East Port Water Reclamation Facility Expansion

Contract #:	2023000485	Change Order #:	4
Original Contract:	\$106,188,600.00	Original Contingency:	\$5,309,430.00
Previous Change Orders:	\$141,963.01	Previous Contingency Changes:	\$249,567.74
This Change:	\$174,921.90	New Contingency Balance:	\$4,884,940.36
Revised Contract Amount:	\$106,505,484.91	Original Contract Time:	900 days days
Current Completion Date:	12/30/2026	Previous Additional Time:	173 days days

CCU Change Order Request
East Port WRF Expansion - Poole and Kent
Change Order #4

Subject: PCO 30- Changes to the effluent boxes on Clarifier #3 & #4
P&K PCO No. 30

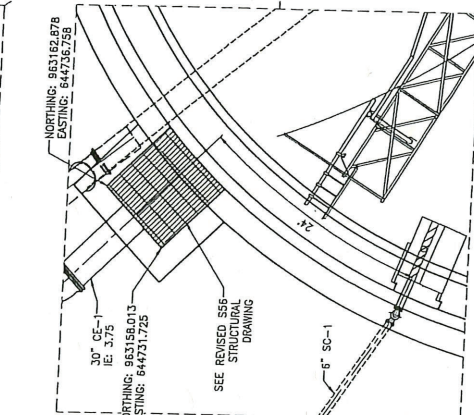
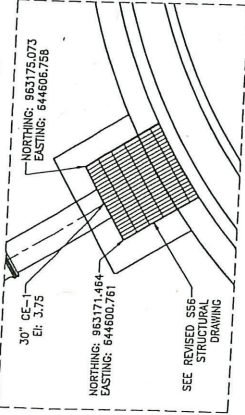
In regards to the 30" effluent lines at Clarifiers 3 & 4, PK potholed to expose both "connection" points. Neither are what is indicated on the drawings. Clarifier #3, the tee is orientated differently from what is shown. Clarifier #4, there is no tie in point, we exposed just pipe, no tee or fittings to connect to. Please see the attached drawing for reference. This is an active line with no way to isolate. For Clarifier #4, advise on how to tie into this line. For Clarifier #3, please advise on how to revise the piping to make the existing connection work or supply us on degrees and angles to rotate the clarifier effluent box to make the connection work.

- Lastly, there also is no 42" x 30" reducer on this line where shown. Potentially 3 or 4 30" effluent lines off the clarifiers will be tying into the same 30" common pipe. Please confirm this is acceptable with flow calculations.

is Described Below or in the Attached: Please refer to the attached PDF pages 2 and 3 for the revised configuration.
The clarifier outfall boxes will be rotated and approximately 3 feet deeper to accommodate the vertical and horizontal alignment to the existing pipe Tie-In locations

NOTES: 1. An additional 30" - 45 degree bend will be required as part of this revision.

2. The Scum Pit box orientation will need to be adjusted as shown. A formal PCM will be posted.

YARD PIPING PLAN

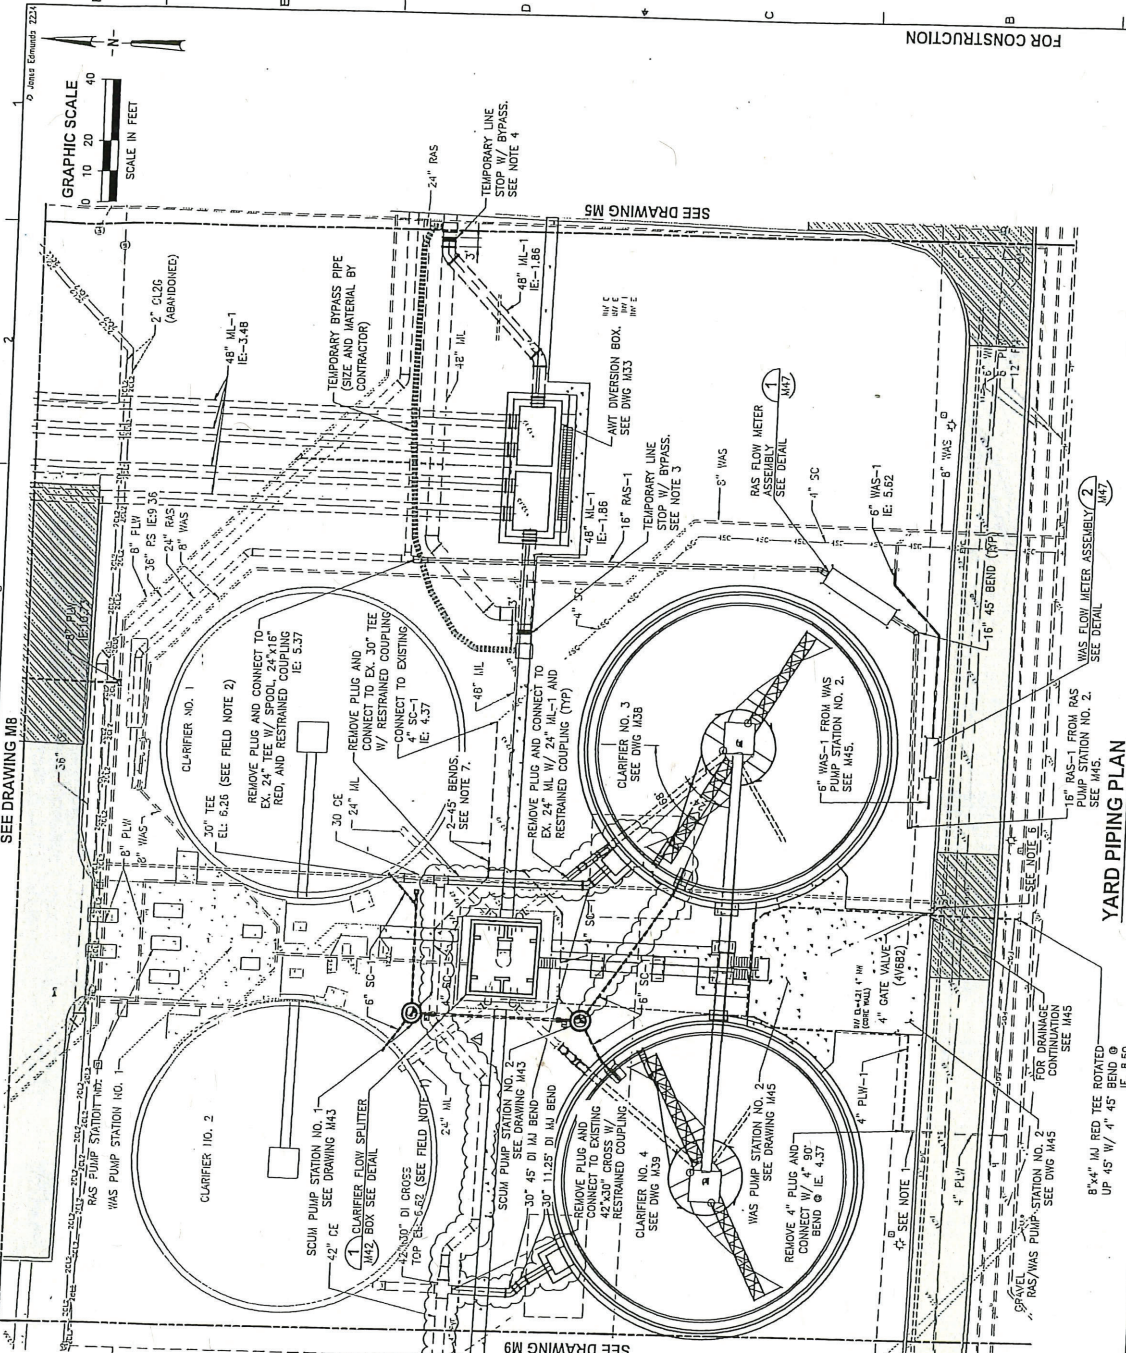
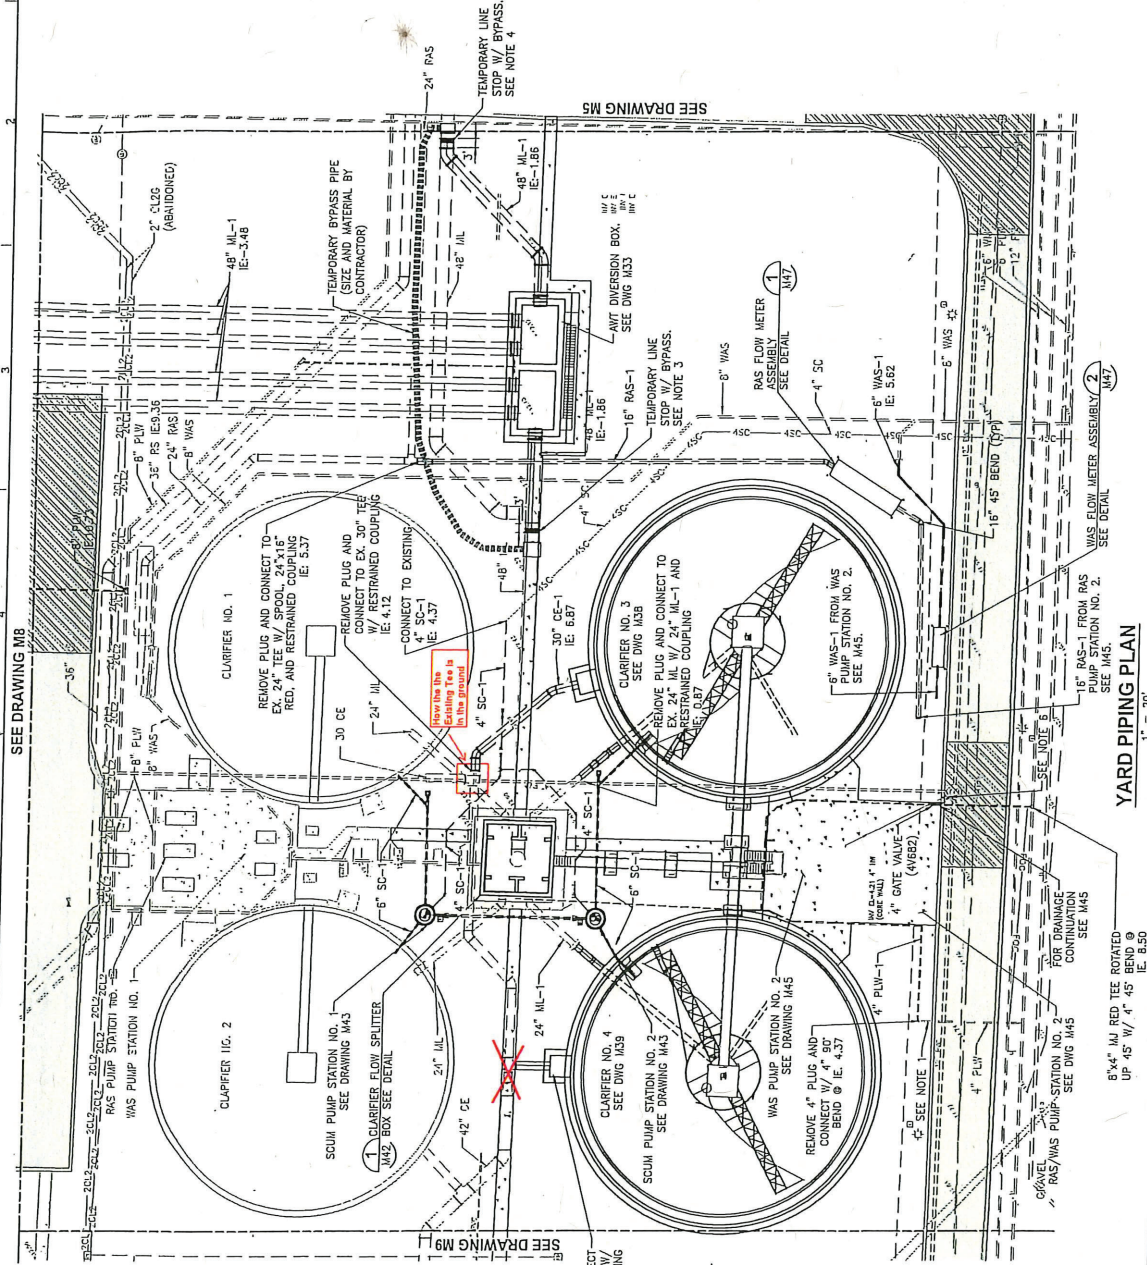
- EXISTING 42"x30" CROSS LOCATION AND ELEVATION WAS VERIFIED IN THE FIELD BY CONTRACTOR, FEBRUARY 2025. TOP OF CROSS ELEVATION IS 6.82.
- EXISTING 30" TEE LOCATION AND ELEVATION WAS VERIFIED IN THE FIELD BY CONTRACTOR, FEBRUARY 2025. TOP OF TEE ELEVATION IS 6.26.

- 2-45° BENDS FROM 6' EL. 10.45 SHOWN ON SHEET M44 TO CONNECT TO EXISTING.
